Access Compliance Report

Public Rights-of-Way

Intersection ID: 10038087	Main Street: SIKES_PL	Cross Street: N/A	Location: E
ADA ID: 53F89BE7C4B1	Ramp Type: Perp	Initial Pass/Fail: Fail	Overall Compliance: No
			Severity Score: 21.25

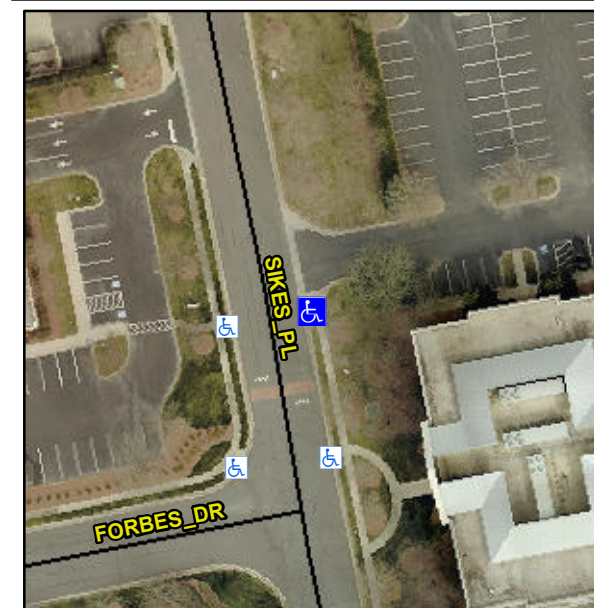
Not Found, R304.5.1, R304.2.2

Compliance	Description	Data	Compliance	Description	Data
N/A	Ramp Length (in)	39.0	No	Ramp Slope (%)	10.2
No	Ramp Width (in)	46.0	Yes	Ramp XSlope (%)	1.2
N/A	Flare Type LT	N/A	N/A	Flare Type RT	N/A
N/A	Flare Slope LT (%)	N/A	N/A	Flare Slope RT (%)	N/A
N/A	Flare Traversable LT?	N/A	N/A	Flare Traversable RT?	N/A
N/A	Landing Length (in)	N/A	N/A	DWS Provided?	N/A
N/A	Landing Width (in)	N/A	N/A	DWS Contrast?	N/A
N/A	Landing Slope (%)	N/A	N/A	DWS Length (in)	N/A
N/A	Landing X Slope (%)	N/A	N/A	DWS Full Width?	N/A
N/A	Landing Curb? (Y/N)	N/A	N/A	DWS Offset (in)	N/A
N/A	Shared Landing?	N/A			
N/A	Gutter Ponding?	N/A	N/A	Gutter Slope (%)	N/A
N/A	Gutter Lip Ht (in)	N/A	N/A	Gutter X Slope (%)	N/A
N/A	Painted X Walk1?	No	N/A	Painted X Walk2?	N/A
	X Walk 1 Direction	To W		X Walk 2 Direction	N/A
N/A	X Walk 1 Width (in)	N/A	N/A	X Walk 2 Width (in)	N/A
	X Walk 1 Slope (%)	3.7		X Walk 2 Slope (%)	N/A
	X Walk 1 X Slope (%)	3.4		X Walk 2 X Slope (%)	N/A

Remove & Replace Entire Ramp.
